GAS MEMBRANE VALIDATION

Site Name: Belle Vue Stadium	Project Number: 12-123
Company Name: Countryside	Date: 31-05-2022
Project Manager: O. Jackson	E3P Engineer: R. Webster
PM Qualifications : BSc FGS AMIEnvSc	Engineer Qualifications: Verification of Gas Protection Systems Dec 2017
Ground Gas Risk Assessment: Amber 1	
<p>Overview:</p> <p>The membrane comprised a Visqueen low permeability gas membrane (Yellow) resistant to radon, carbon dioxide and low levels of methane. E3P can confirm there were no holes or rips at the time of inspection. Upon being laid the membrane is to be covered with a Celotex (closed Cell) floor insulation material which is considered to provide a high degree of protection.</p> <p>All external joints were inspected and E3P can confirm that the membrane was overlapped and double taped to external and internal gas resistant DPM. The membrane was taped to the gas resistant DPM using a double-sided jointing tape.</p> <p>Each unit has a service duct located to the front and outer edge of the property. E3P inspected each one and can confirm that the top-hats have been adequately sealed against the membrane.</p> <p>Based on the information provided within this repo

Plot - 100

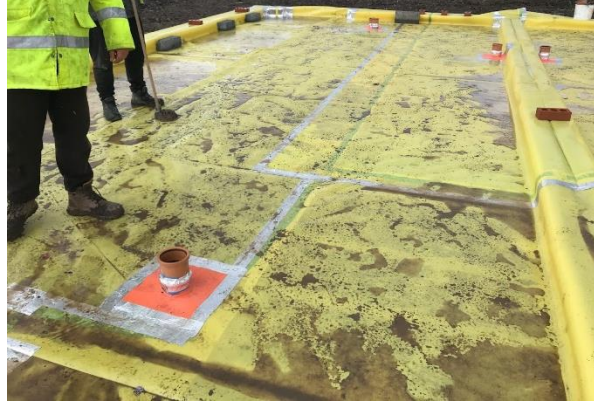
General Condition of Membrane-Good Condition

Verification of Joints and Seals-Overlapped and sealed correctly

Verification of Service Penetrations-Good Condition

Plot - 101

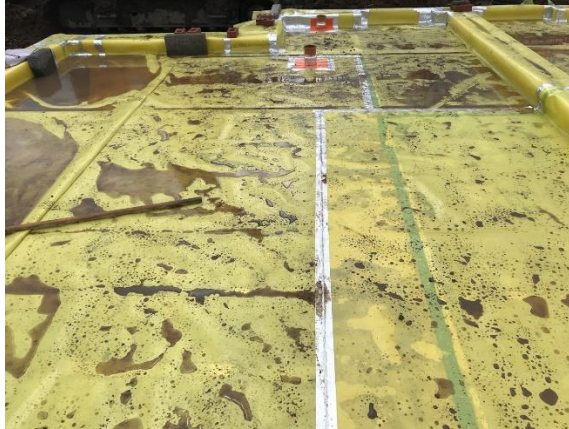
General Condition of Membrane-Good Condition

Verification of Joints and Seals-Overlapped and sealed correctly

Verification of Service Penetrations-Good Condition

Verification of Ventilation-Good Condition
